Information to Customers

Confirmation of mounting positions for SHARP Solar Modules NDAKxxx(h) and NUAKxxx(H)

Clamping on long side:

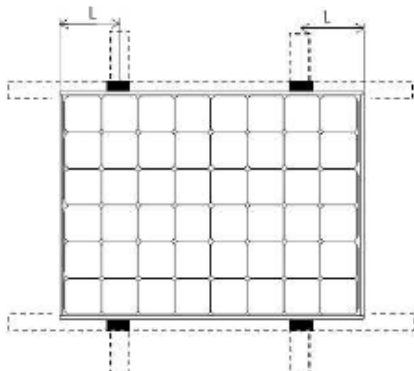
Sharp Electronics GmbH confirms, that the below mentioned Module series could be mounted with clamps under below described conditions as an extension of the actual Installation Manual. Furthermore, the test load according Mechanical Load Test (MQT16) of EN61215-2 is 2.400Pa. The installation manual attached to the Modules remains valid. The Product- and Power Output Guarantee in the version at the date of purchase by the end user remains valid. Damages caused by mechanical overload are excluded from the Product Guarantee.

ND-AKxxx(H), NU-AKxxx(H)

L between 0 and $\frac{1}{4}$ * Module length from the corner
